Access Compliance Report

Public Rights-of-Way

Intersection ID: 29144	Main Street: DEATON_HILL_DR	Cross Street: HUNTERS_CREEK_CT	Location: NW
ADA ID: 31F84B9C0E0D	Ramp Type: PerpDiag	Initial Pass/Fail: Fail	Overall Compliance: No
Severity Score: 22.5			
Codes/Mitigation Info/Possible Solution		Field Measurements/Component Compliance

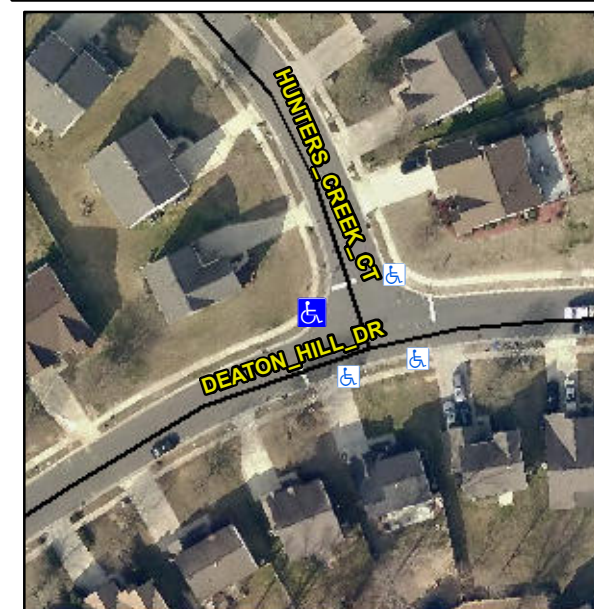
Remove & Replace Curb Ramp With Two New Directional Ramps or Equivalent.

R304.5.1, R304.2.2, R304.5.3

Compliance	Description	Data	Compliance	Description	Data
N/A	Ramp Length (in)	48.0	No	Ramp Slope (%)	8.4
No	Ramp Width (in)	47.5	No	Ramp XSlope (%)	4.1
N/A	Flare Type LT	N/A	N/A	Flare Type RT	N/A
N/A	Flare Slope LT (%)	N/A	N/A	Flare Slope RT (%)	N/A
N/A	Flare Traversable LT?	N/A	N/A	Flare Traversable RT?	N/A
N/A	Landing Length (in)	N/A	N/A	DWS Provided?	N/A
N/A	Landing Width (in)	N/A	N/A	DWS Contrast?	N/A
N/A	Landing Slope (%)	N/A	N/A	DWS Length (in)	N/A
N/A	Landing X Slope (%)	N/A	N/A	DWS Full Width?	N/A
N/A	Landing Curb? (Y/N)	N/A	N/A	DWS Offset (in)	N/A
N/A	Shared Landing?	N/A			
N/A	Gutter Ponding?	N/A	N/A	Gutter Slope (%)	N/A
N/A	Gutter Lip Ht (in)	N/A	N/A	Gutter X Slope (%)	N/A
N/A	Painted X Walk1?	No	N/A	Painted X Walk2?	No
	X Walk 1 Direction	To S		X Walk 2 Direction	To E
N/A	X Walk 1 Width (in)	N/A	N/A	X Walk 2 Width (in)	N/A
	X Walk 1 Slope (%)	5.3		X Walk 2 Slope (%)	0.9
	X Walk 1 X Slope (%)	1.8		X Walk 2 X Slope (%)	4.7
